WACONIA PLANNING COMMISSION MEETING AGENDA

**Thursday, August 7, 2025
6:30 PM**

REQUEST FOR PLANNING COMMISSION ACTION

Meeting Date:	August 7, 2025
Item Name:	4.2. PUBLIC HEARING - Elm Creek Ridge Preliminary Plat, PUD Zoning Request & Comprehensive Plan Amendment
Originating Dept:	Community Development
Presented By:	Lane Braaten
Previous Council Action:	
Item Type:	Regular Session

PROJECT NO.
 25-142
 L1.4

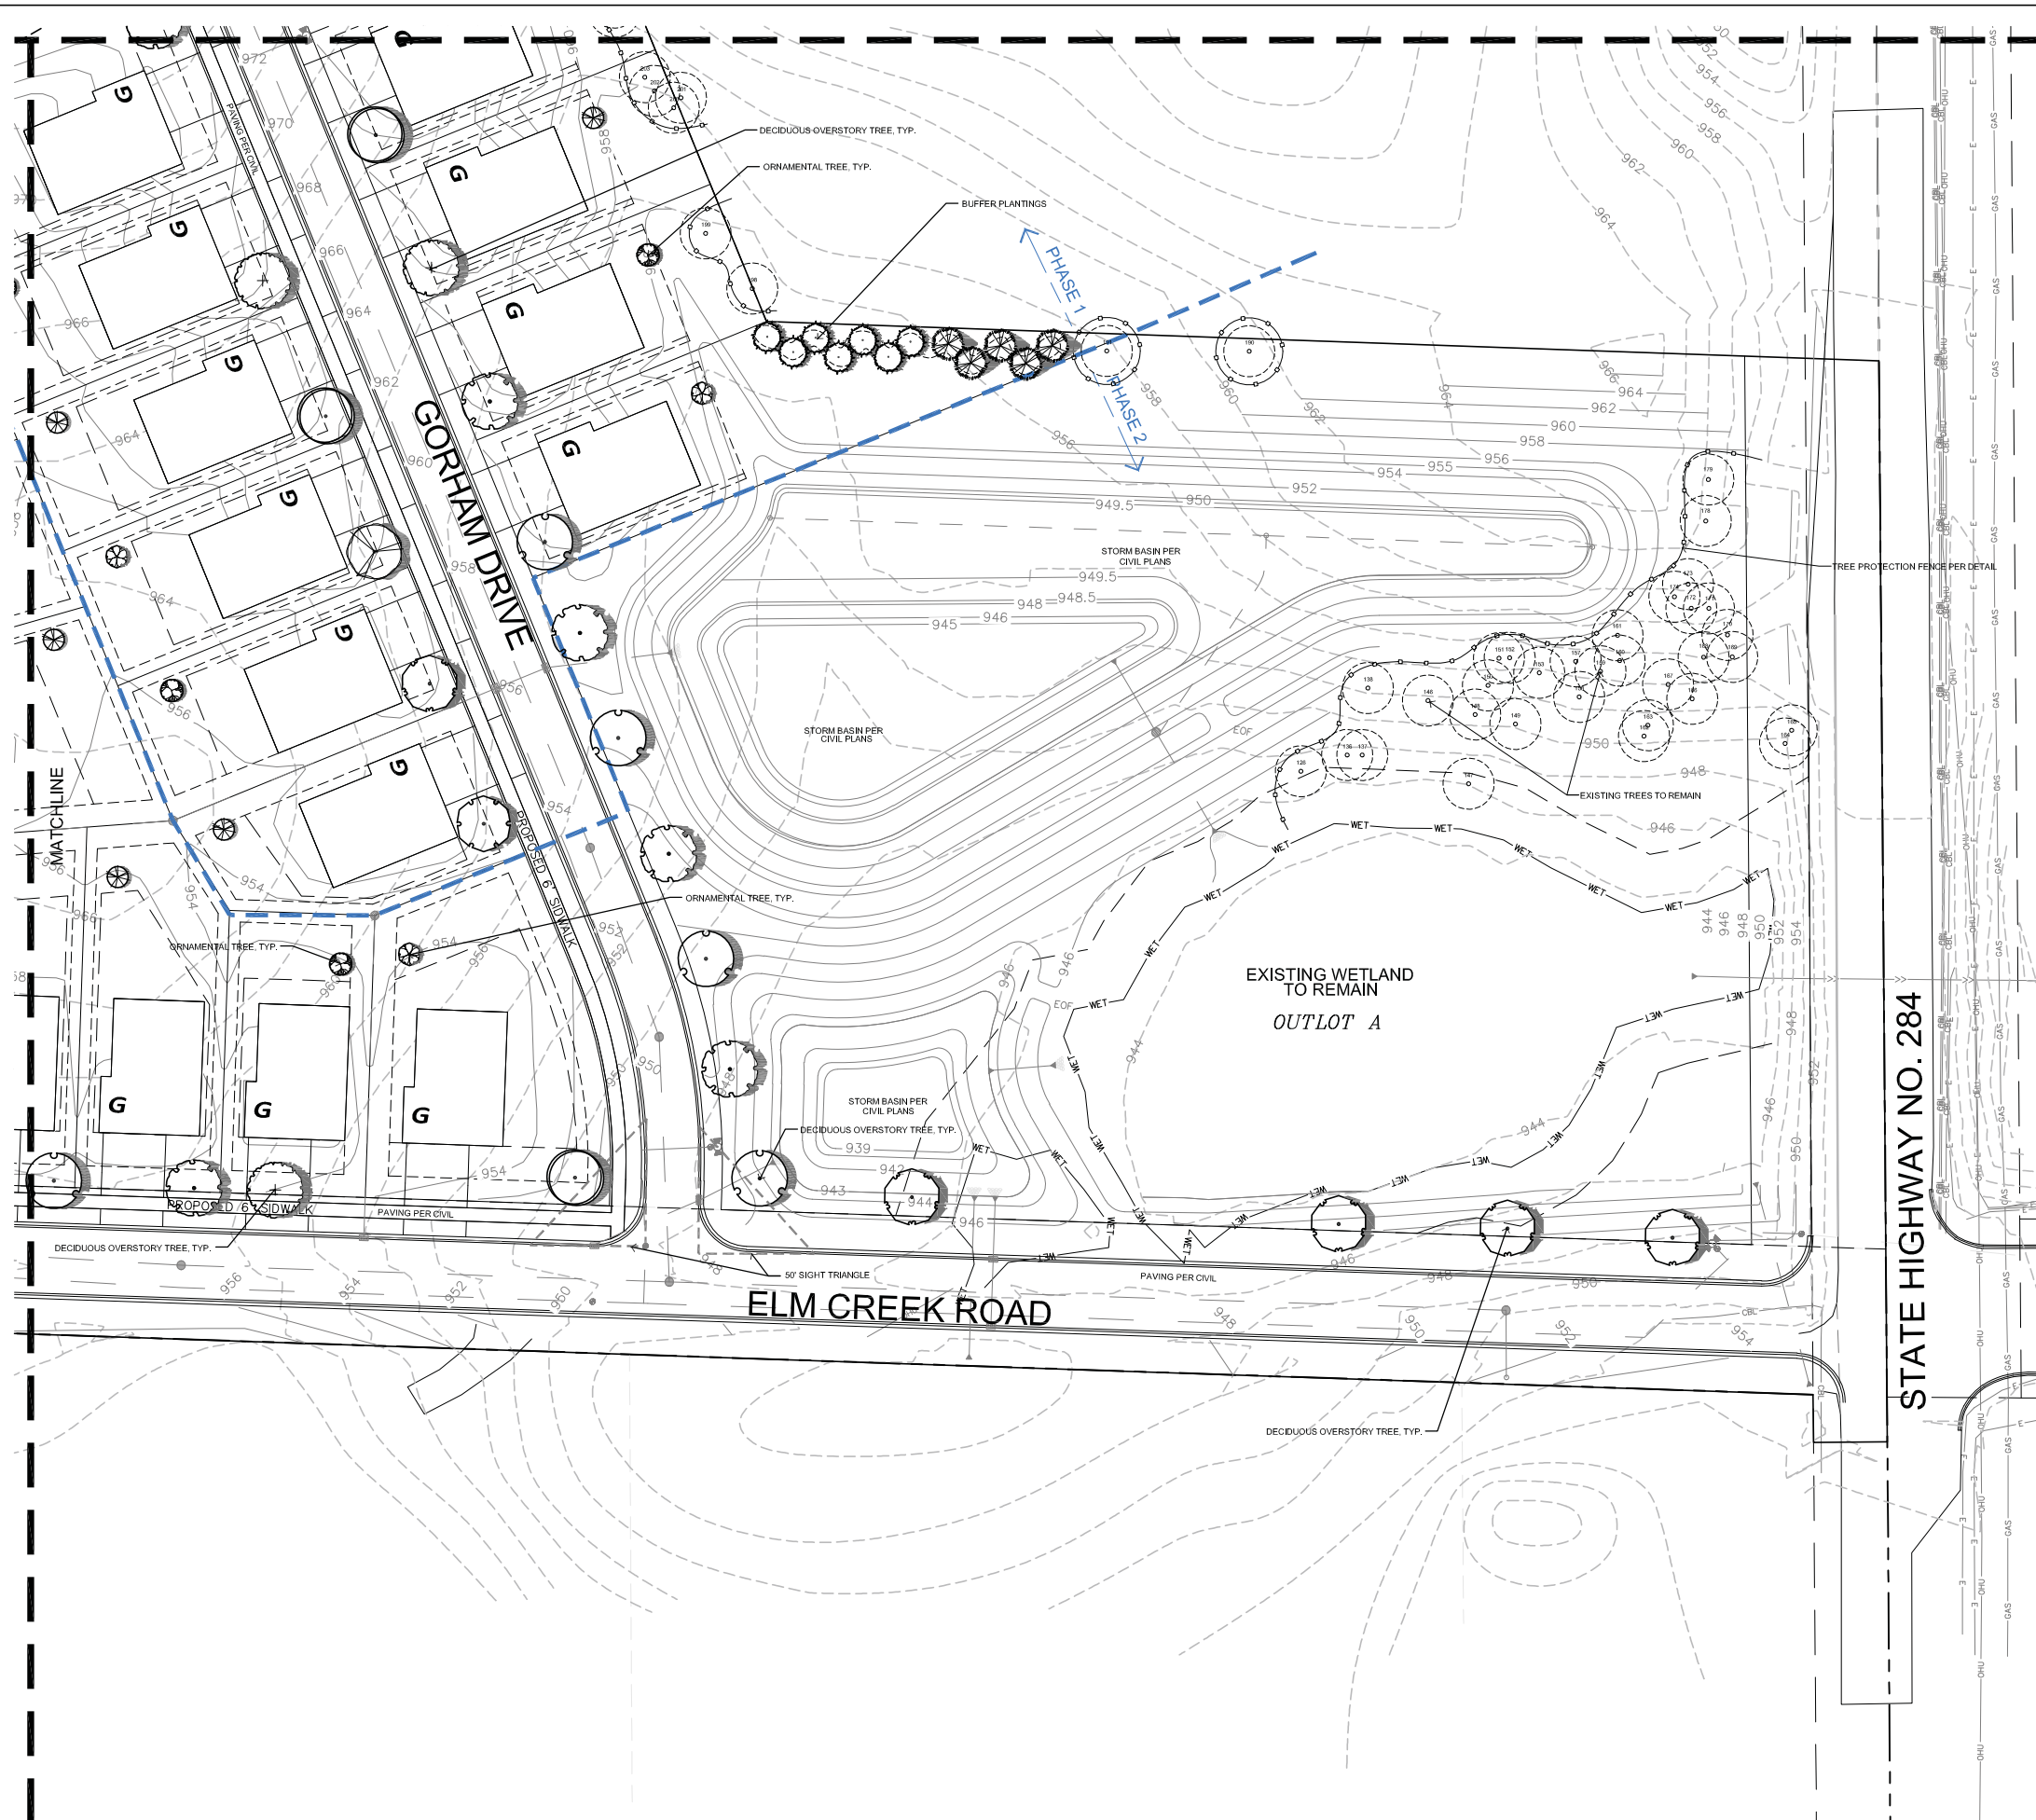
1. Additional coniferous plantings along Outlot C near the intersection of Gorham Drive and Huntington Drive to screen automobile lights.
2. The applicant should identify possible areas where additional screening plantings may be located to further screen the property owners to the south.

The landscape plan shall be revised to include the following:

1 EXTERIOR ELEVATION - PB3
SCALE: 1/16" = 1'-0"

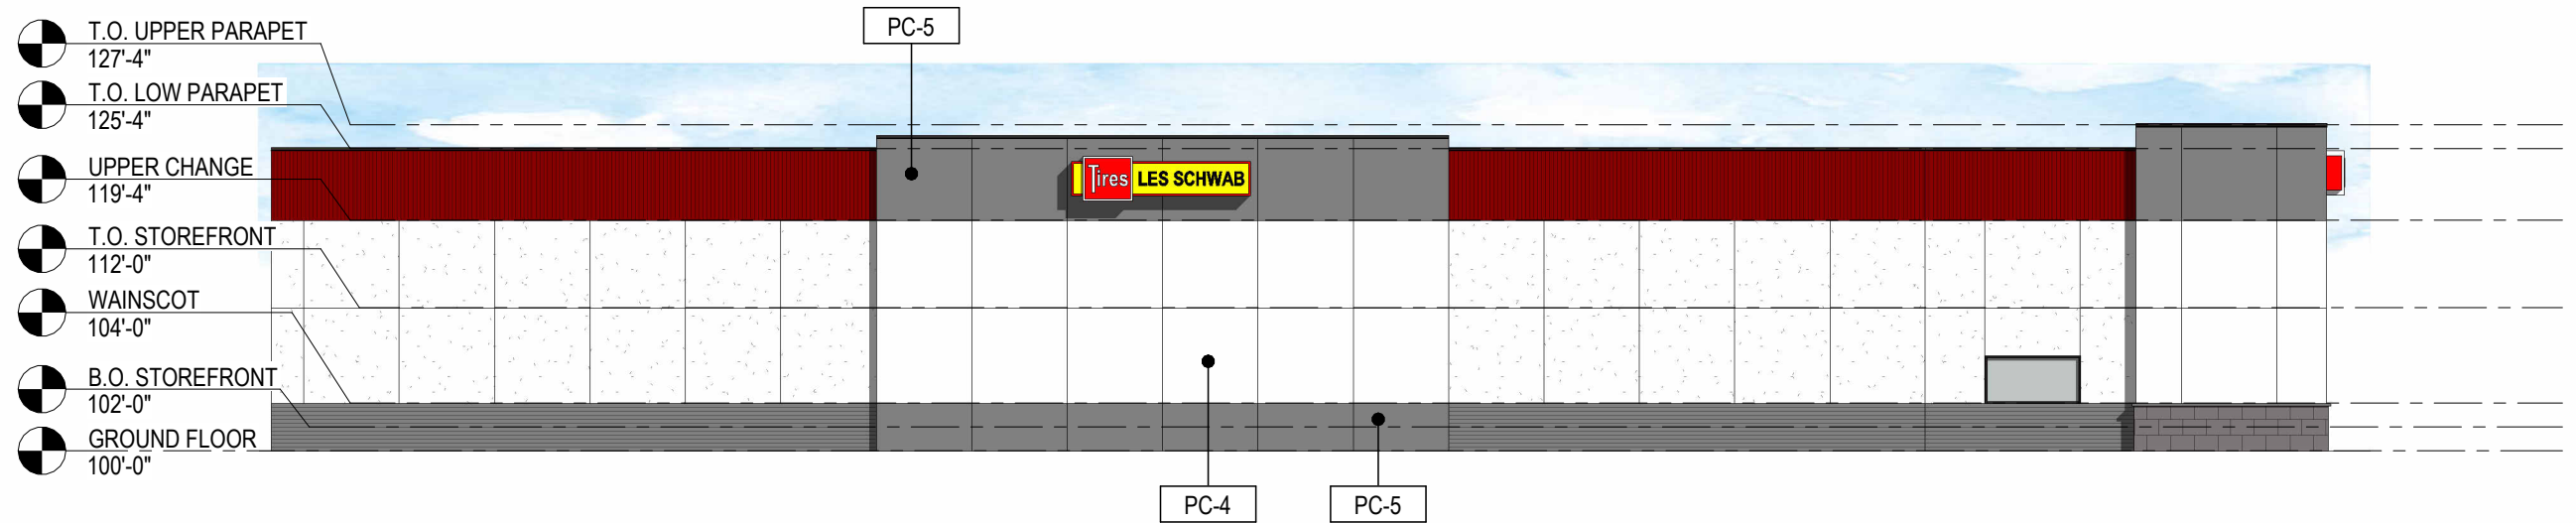
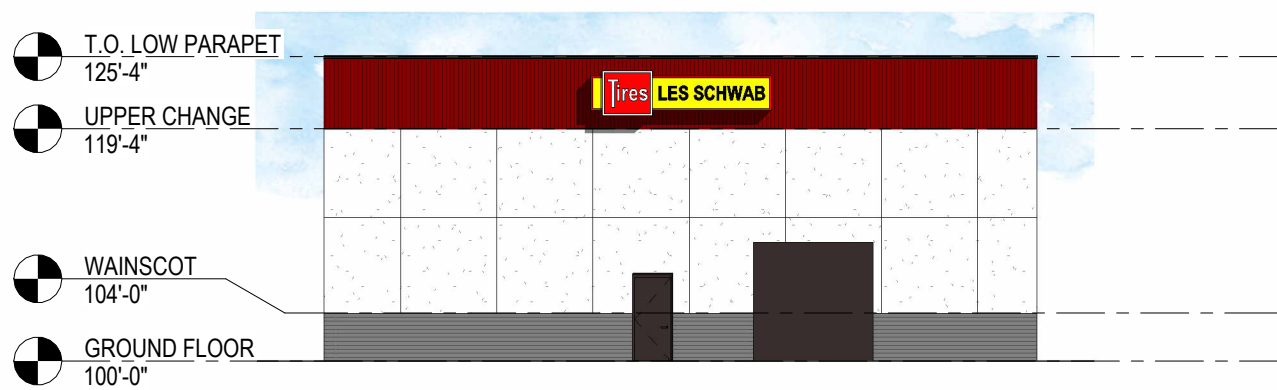
The exterior rear elevation of the building identified on sheet P3 Exterior Elevations – PA should require some vertical variation, or other improvement, to reduce the perceived length

1 EXTERIOR ELEVATION - PC3
SCALE: 1/16" = 1'-0"

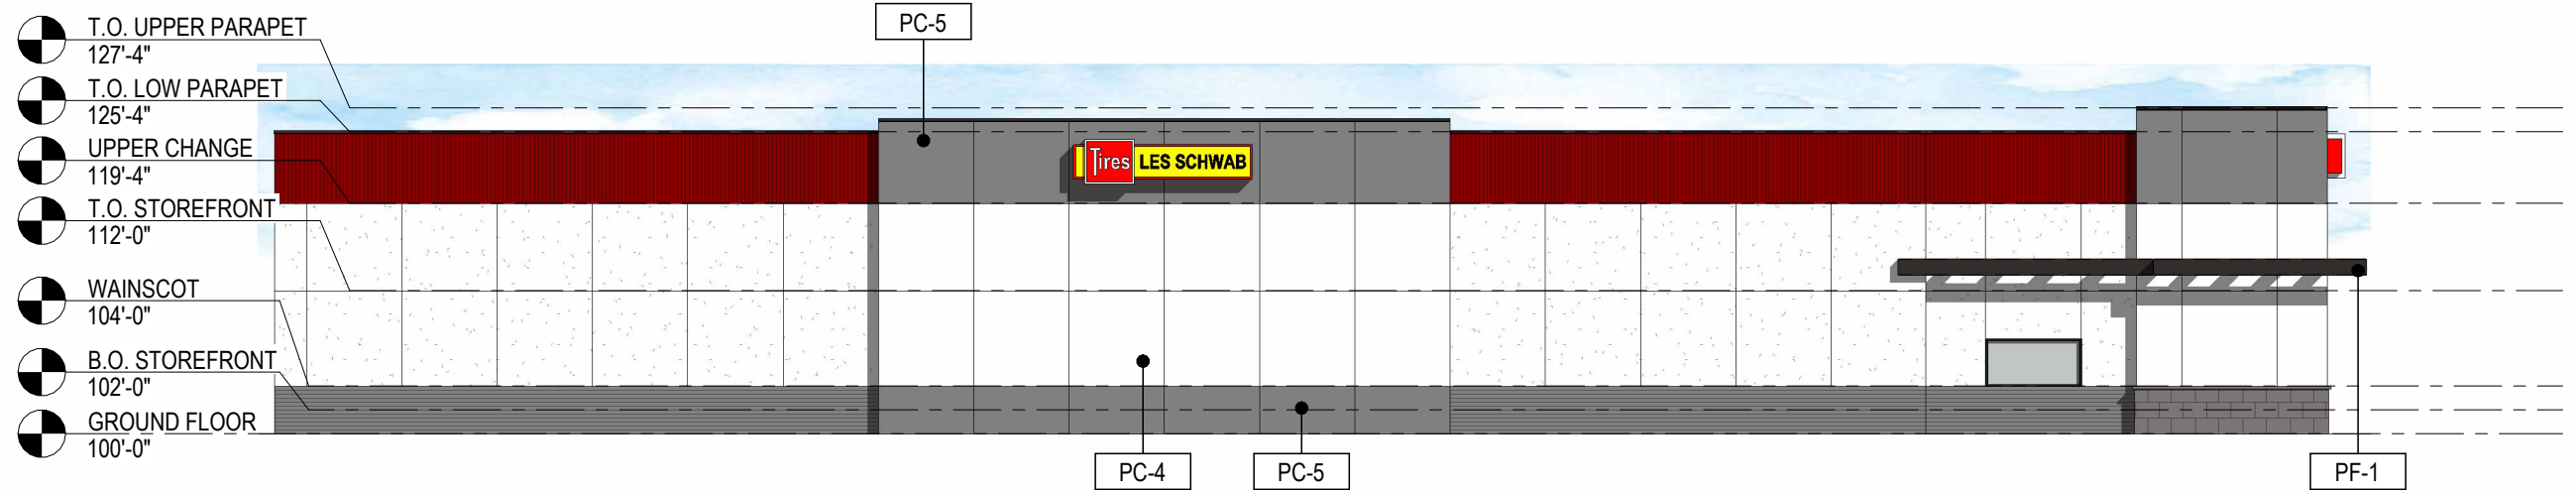
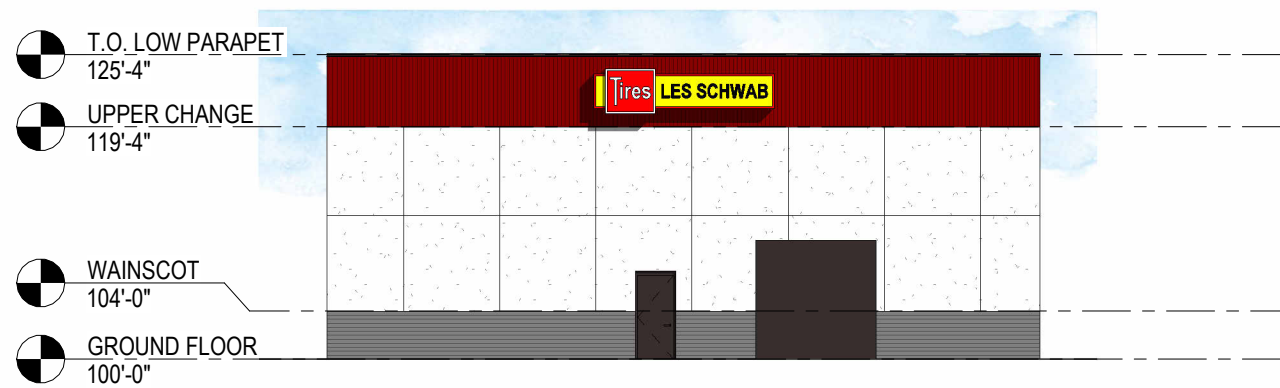
and bulk of the building consistent with the objectives and standards above. The exterior rear elevation shown on sheet P9 Exterior Elevations – PC is consistent with this standard.

12. The final exterior rear elevation of the building shall be consistent with the exterior rear elevation shown on sheet P9 Exterior Elevations – PC, which is consistent with the

13. The exterior design treatments identified in sheets P8 Exterior Elevations – PC and P9 Exterior Elevations – PC are consistent with the Highway District Design Standards and shall be the standard used when constructed.
14. The applicant shall provide the applicable rooftop or ground mounted screening details for review and approval prior to issuance of a building or mechanical permit.
15. The applicant shall contact the City Planning Department for a final site inspection when all conditions of approval regarding this application have been completed.
